Inspection of Automatic Sprinkler System

East London Industrial Development
Zone - SOS Cheese Factory

UNC.10601

20.06.2024 08:46 SAST

Photo 16

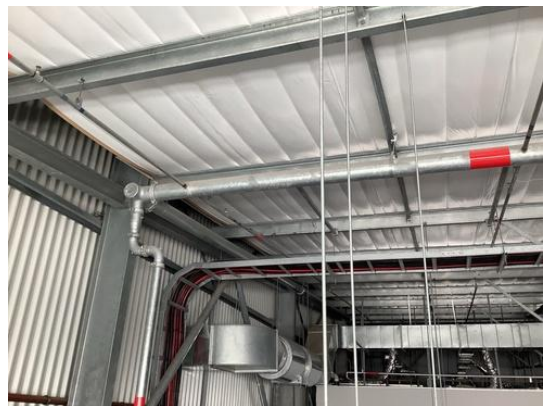
The sprinkler pipe work must be correctly supported.

Photo 18

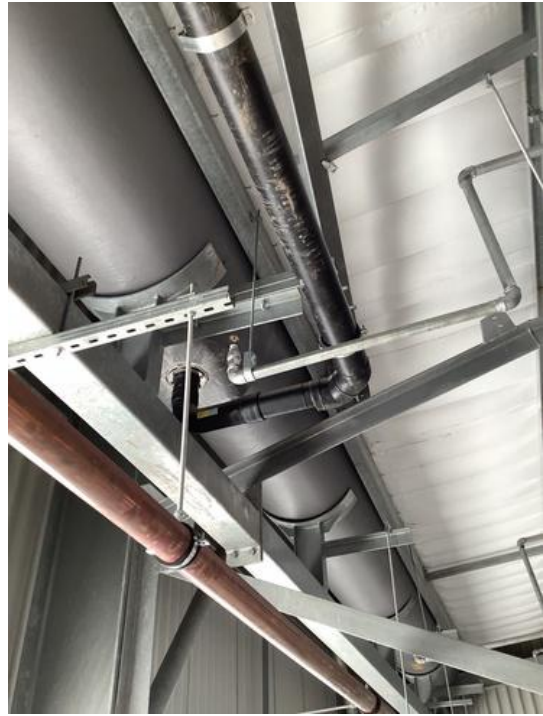
The sprinklers are spaced too far from roof/ceiling level.

Combustible maximum 300 mm / Non-combustible maximum 450 mm.

Photo 22

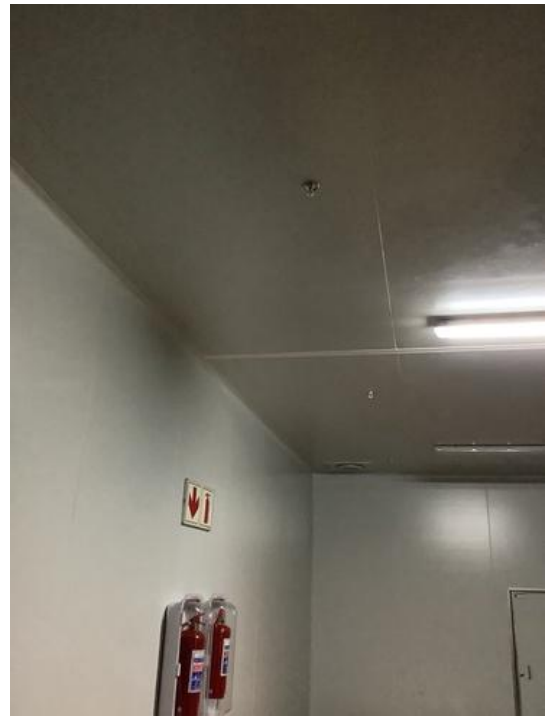
Sprinklers exceed 600 mm from walls of a cold room or freezer (11th Edition).
